31 August 2001
DCS-NRC-000060

Subject: Docket Number 070-03098
Duke Cogema Stone & Webster
Mixed Oxide Fuel Fabrication Facility
Response to Request for Additional Information

Non-Proprietary Response to Request for Additional Information

Figure RAI-012-5. EPRI mean and fractile uniform hazard spectra for SRS hard-rock site conditions for an approximate annual probability of exceedance of 10^{-4} .

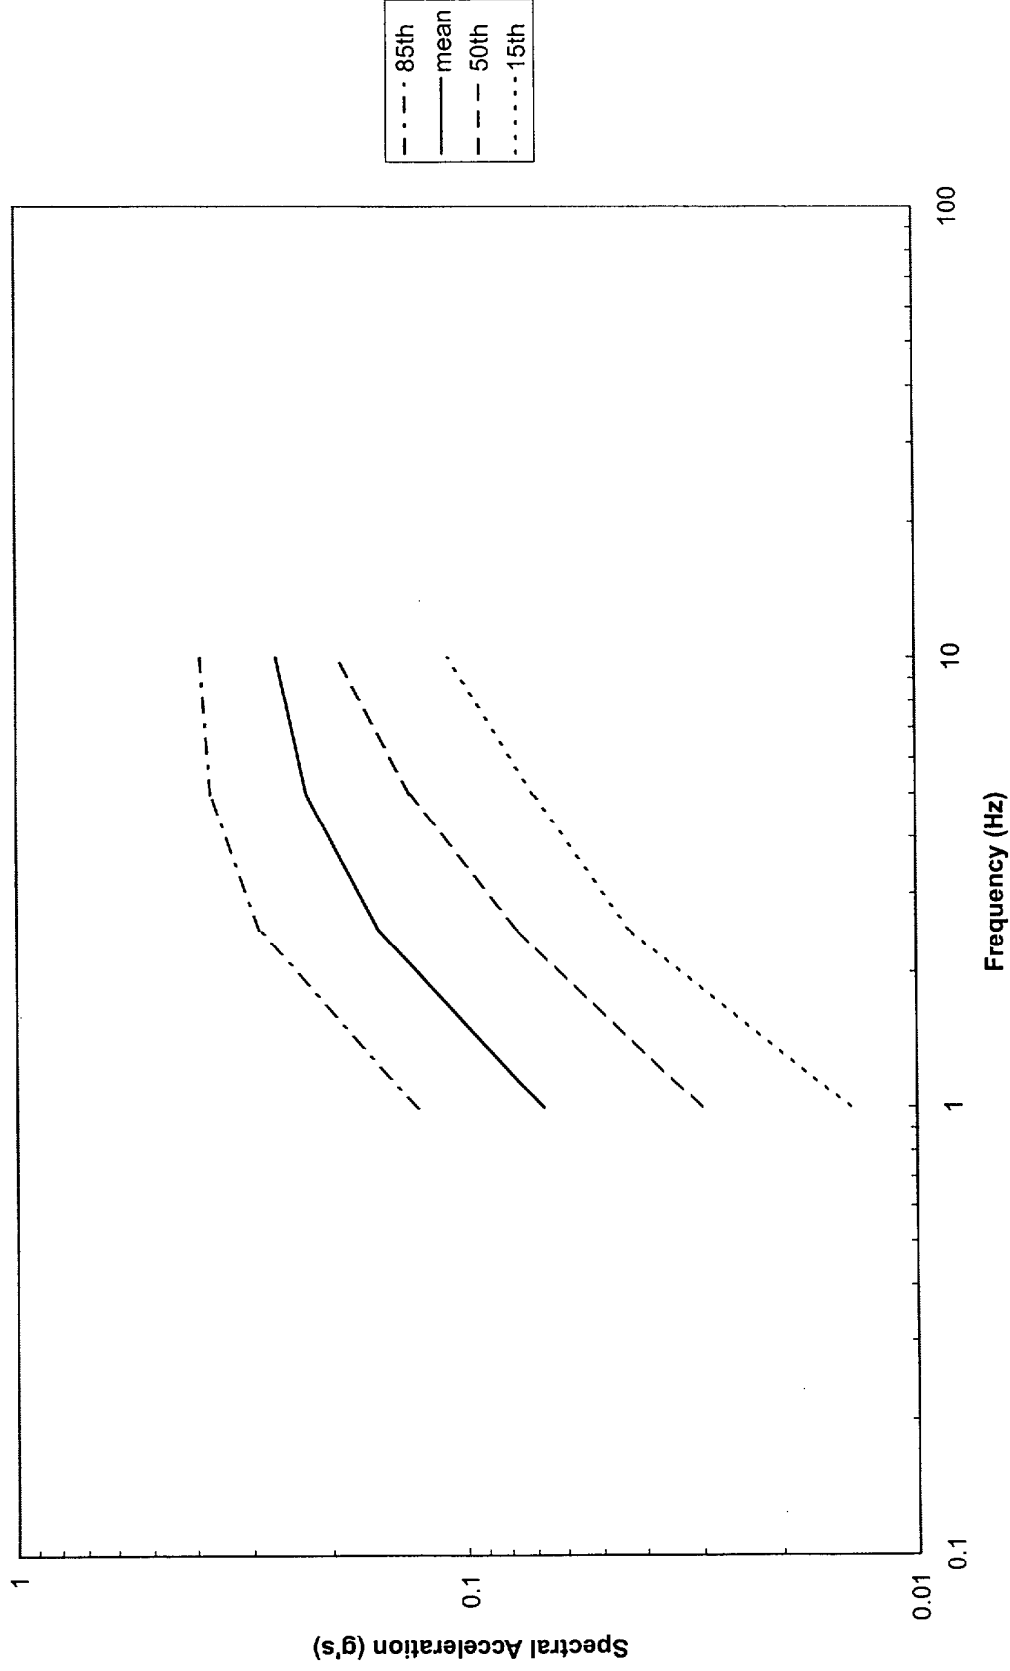
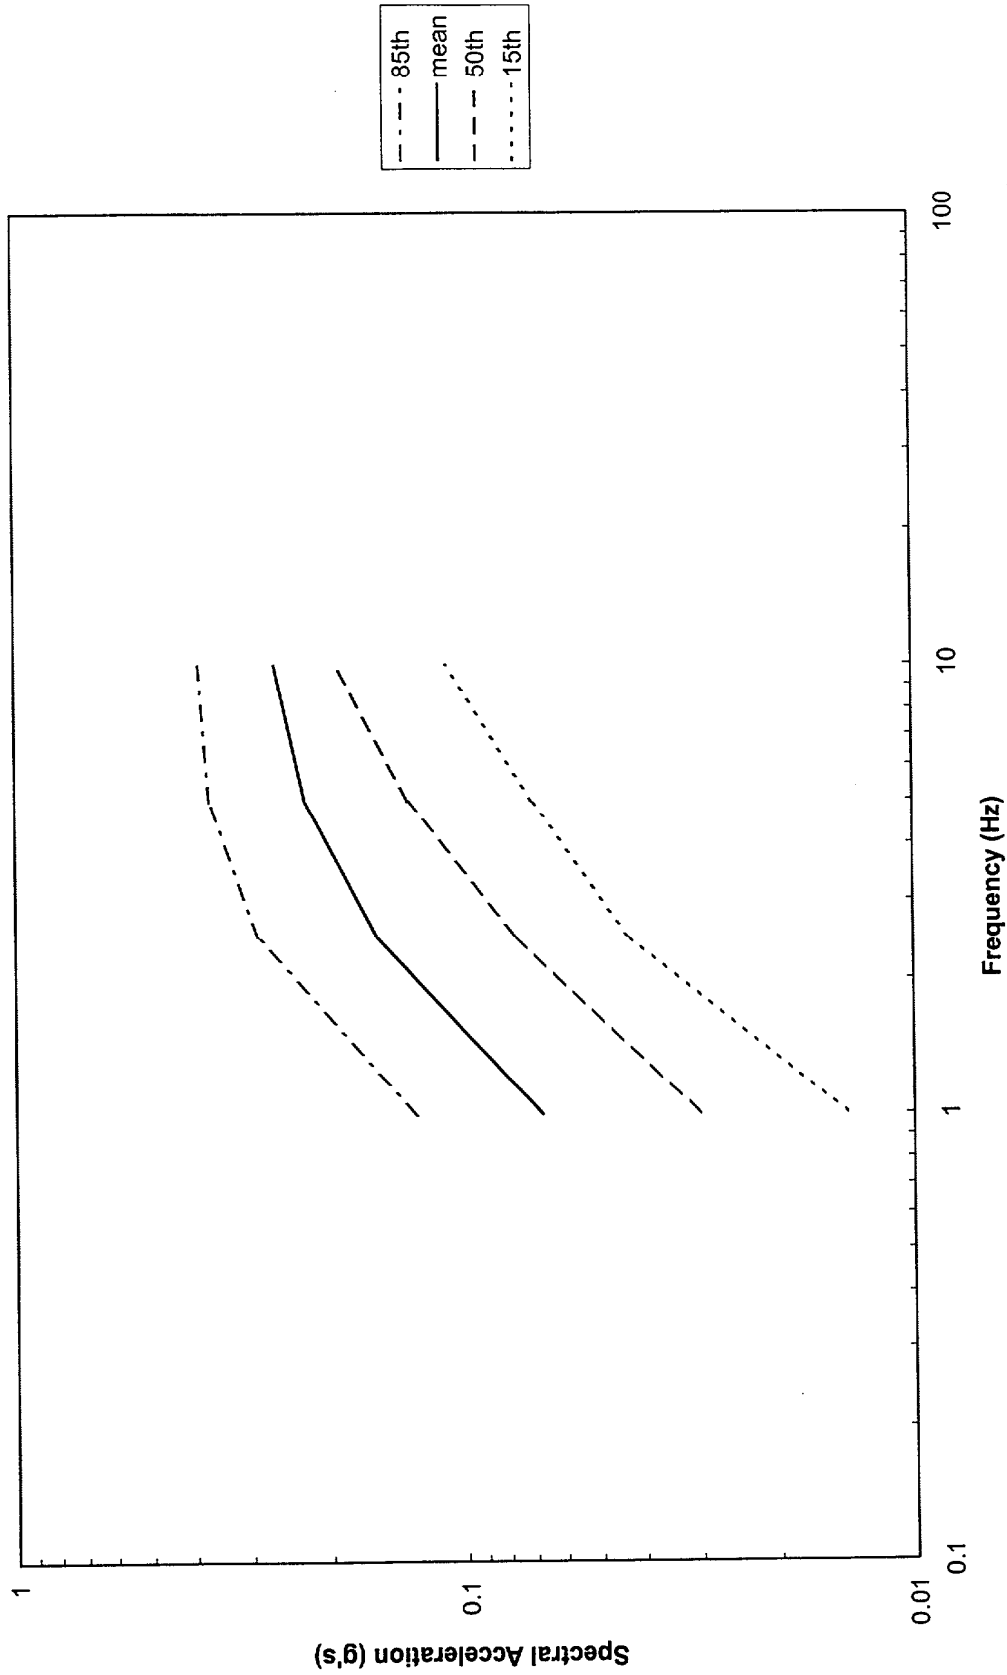
Response 12d.

EPRI mean and fractile hard-rock uniform hazard spectra (UHS) for the SRS are illustrated in the attached Figure 5 for an approximate annual probability of exceedance of 10^{-4} .

Figure RAI-20-1 SRS Soil Surface Seismic Hazard Curves

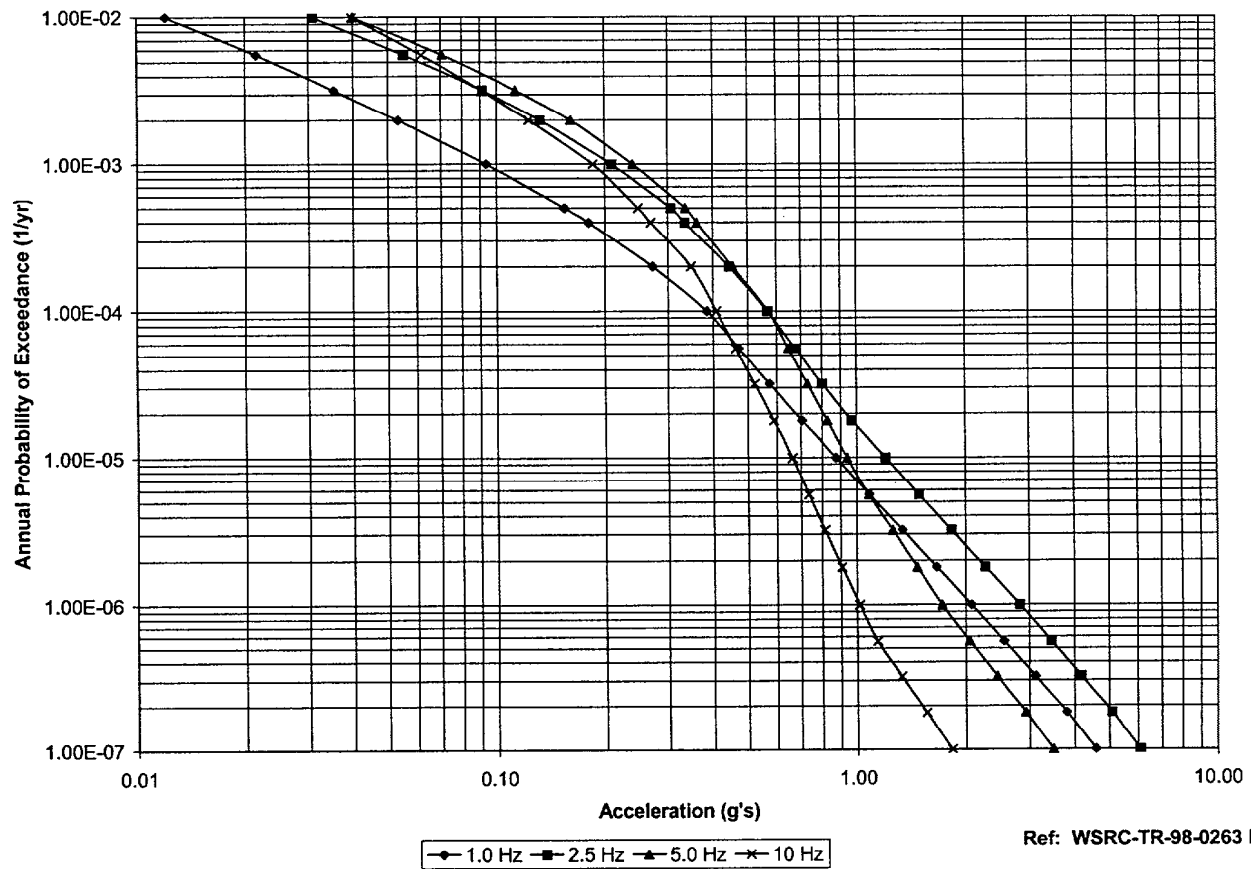
It appears from the application that the return periods were chosen from 5 Hz spectrum accelerations (Table 1.3.6-7 and Figure 1.3.6-16). The applicant did not give the bases and purposes for evaluation of return periods from 5 Hz spectrum accelerations.

Section 1.3.6.6 on page 1.3.6-23 describes the selection of the MFFF Design Earthquake, using the SRS site-wide criteria as an input. The narrative refers to Figure 1.3.6-16 as representing the soil surface hazard relationships for SRS. Figure 1.3.6-16 expresses the hazard in terms of spectral velocity versus annual probability of exceedance. The source document that developed this hazard definition (WSRC, 1998, shown in the CAR as "Lee, R.C., 1998,") also contains representations of the hazard in terms of spectral acceleration. The attached Figure RAI-20-1 shows the appropriate soil surface acceleration hazard curve.

Using the acceleration hazard relationships shown in Figure RAI-20-1 for each of the four oscillator frequencies (1 Hz, 2.5 Hz, 5 Hz, and 10 Hz) represented in the hazard chart, the spectral acceleration was read off each of the 5% damped response spectra discussed (CAR - Figure 1.3.6-20 for PC-3, Figure 1.3.6-14 for PC-4, and Figure 1.3.6-21 for Regulatory Guide 1.60). These spectral accelerations were used to enter Figure RAI-20-1 and to read the associated annual mean probability of exceedance. Inverting the annual mean probability of exceedance results in the return period reported in CAR Table 1.3.6-7.

To provide additional clarity, Figure RAI-20-1 will be included in the next update of the CAR, and will be cited in CAR Section 1.3.6.6.

DCS Operations Phase

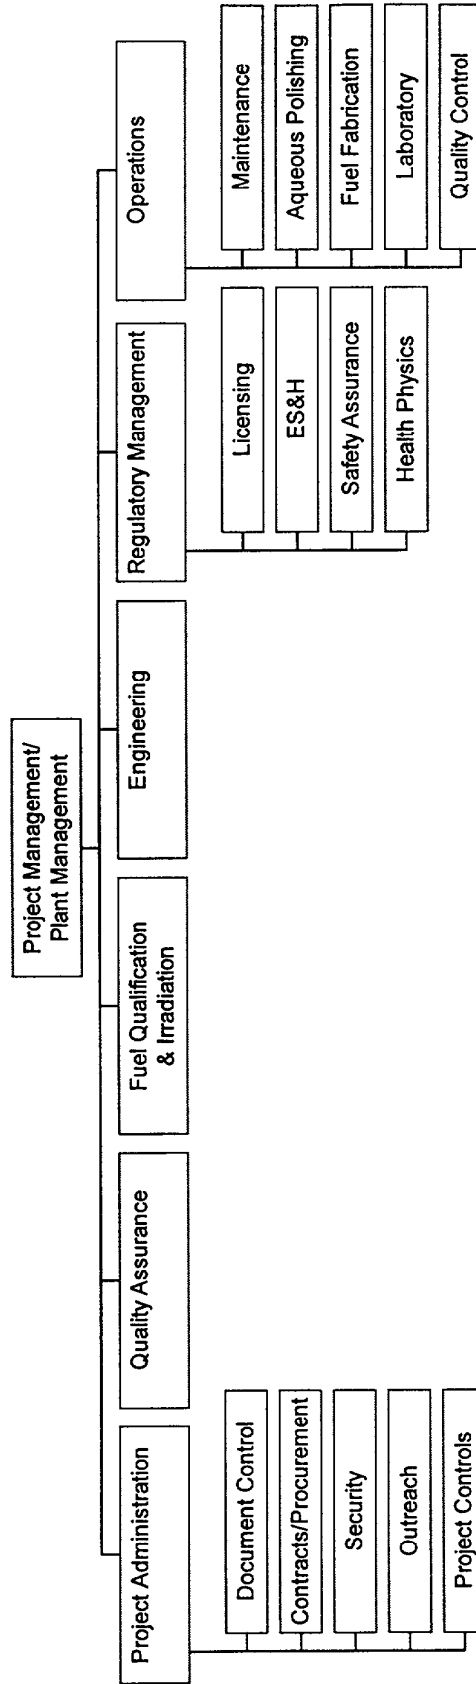
Figures 4-1 and 4-2 provide organizational charts. The NRC would anticipate that Figure 4-1 would be more explicit vis-a-vis positions, the location of the Safety Assessment manager and safety activities, and current design and regulatory activities. Current names and qualifications of individuals should be supplied. In addition, on Figure 4-2, the NRC would anticipate, there should be a link between regulatory manager and corporate management, including corporate safety management.

Figure 4-2 has been updated to show the functional relationships of the organization for the operations phase of the project. This organizational chart (see attached sketch) details the proposed DCS organization for the operations phase of the project. The organization for the initial operation phase will include the engineering, construction, and start-up elements until final turnover to operations is complete.

In the next update of the CAR, replace Figures 4-1 and 4-2 with the new project, construction, and operations charts; add position descriptions for the additional positions indicated above; and clarify reporting relationships as discussed above.
